Addendum 126 – Regulation No. 127

Revision 4 - Amendment 1

Supplement 1 to the 04 series of amendments to the Regulation – Date of entry into force: 5 January 2024.

Uniform provisions concerning the approval of motor vehicles with regard to their pedestrian safety performance

Figure 12
Windscreen test area

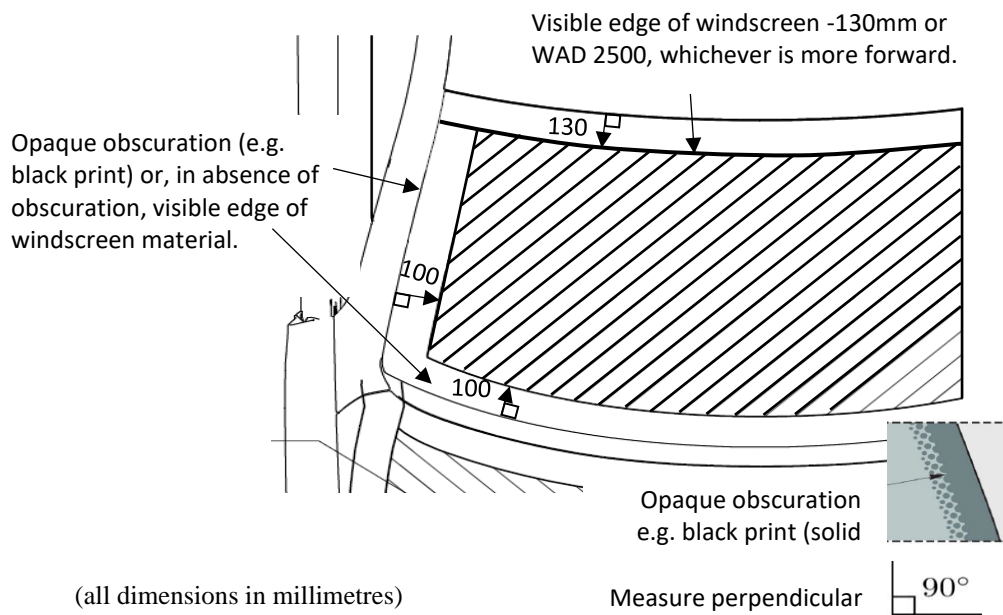
Paragraph 2.44., amend to read and insert Figures 12 and 13:

- "2.44. "Windscreen test area" is an area on the outer surface of the windscreen. It is bound (see figure 12):
- (a) In the front, by a line 100 mm rearward to the opaque obscuration of the windscreen. In case of absence of the opaque obscuration, the line is measured from the front visible edge of the windscreen material.
 - (b) In the rear, by a WAD 2,500 or a line 130 mm forward to the rear visible edge of the windscreen material, whichever is more forward at a given lateral position.
 - (c) At each side, by a line 100 mm inside the opaque obscuration of the windscreen. In case of absence of the opaque obscuration, the line is measured from the side visible edge of the windscreen material.

For (a) and (c): the distances of 100 mm are to be measured with a flexible tape held tautly along the outer surface of the vehicle at an angle of 90° to the tangent line to the opaque obscuration limit or in case of absence of the opaque obscuration, from the visible edge respectively.

For (b): the distances of 130 mm is to be measured with a flexible tape held tautly along the outer surface of the vehicle at an angle of 90 ° to the tangent line to the rear visible edge of the windscreen.

Figure 13
Upper corner definition with "shortest distance"

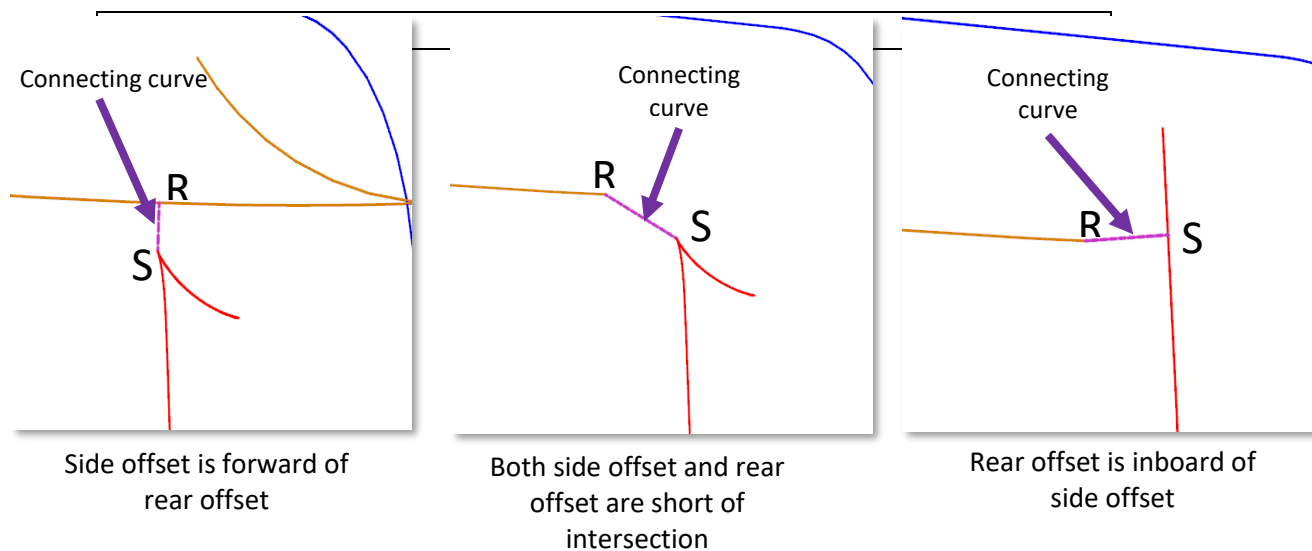
Depending on the geometry, in case there is no intersection between (b) and (c), resulting in an open test area, then the marking shall be modified using the shortest distance to close the open test area (see figure 13).

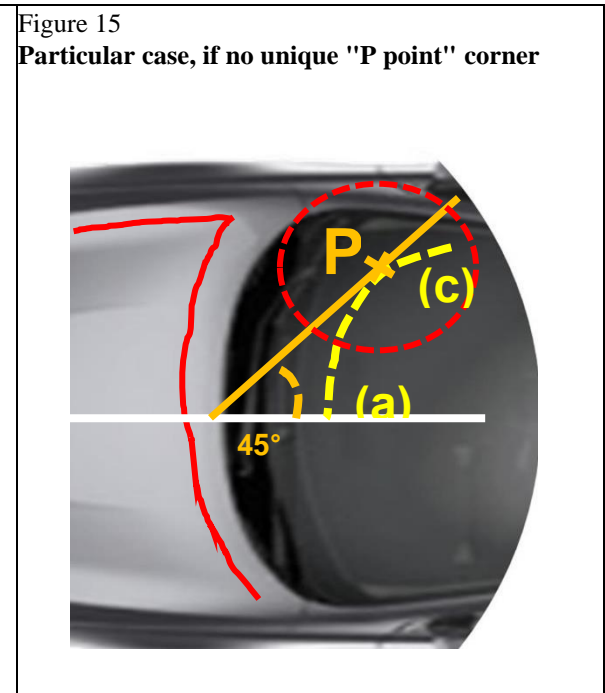
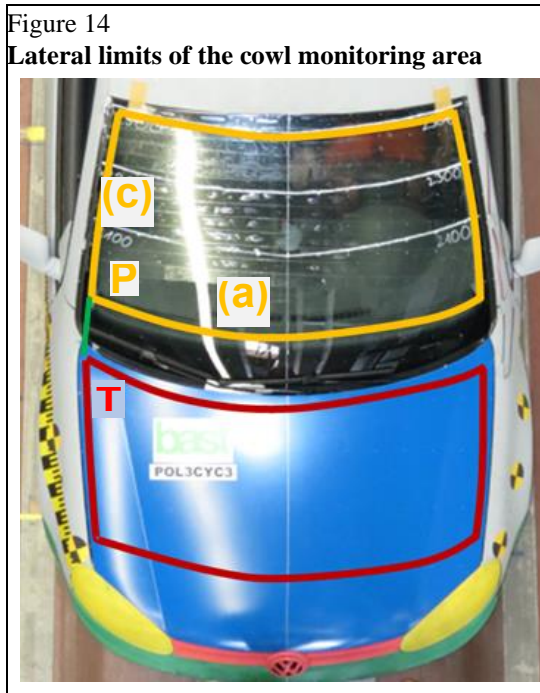
Paragraph 2.45., insert Figures 14 and 15 and amend to read:

At each side, the cowl monitoring area is bound by the TP line (see figure 14), where:

- (a) the "T point" is the rear corner of the bonnet top test area; and
- (b) the "P corner point" is the lower corner of the windscreen test area; using a flexible tape held tautly from point T to P.

If there is no unique "P point" where the lines defined in 2.44 (a) and (c) intersect, then the "P point" is defined by the first contact of a vertical plane intersecting the vertical longitudinal vehicle center-plane at an angle of 45° with the (a)-(c) transition of the windscreen test area boundary, as shown in Figure 15.

Figure 16
Jerk criterion graph and formula

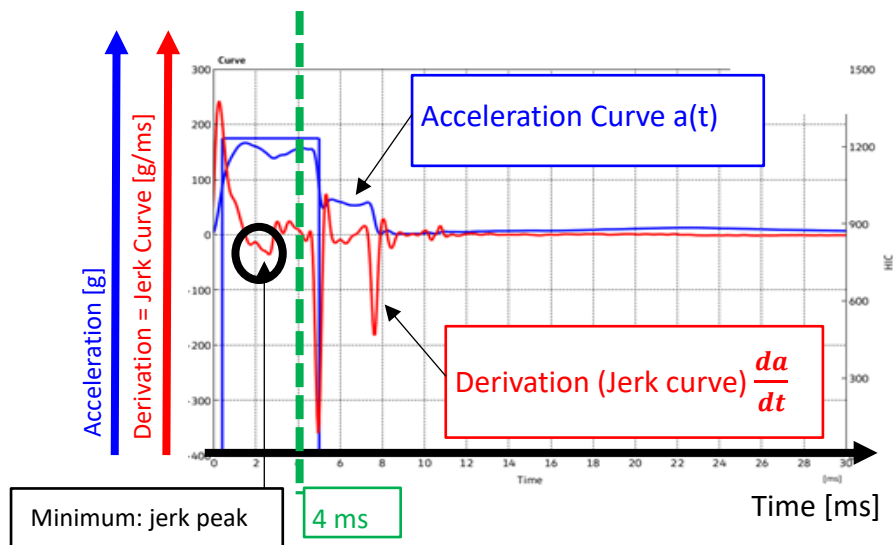
Paragraph 2.48., insert Figure 16 and amend to read:

- (a) The absolute value of the minimum value of the derivation of the headform acceleration versus time is less than 180 g/ms within the first 4 ms after the initial contact of the headform to the windscreen, as shown in Figure 16; or

$$\left| \min \left(\frac{da}{dt} \right) \right| < 180 \text{g/ms, for } 0 < t < 4 \text{ms}$$
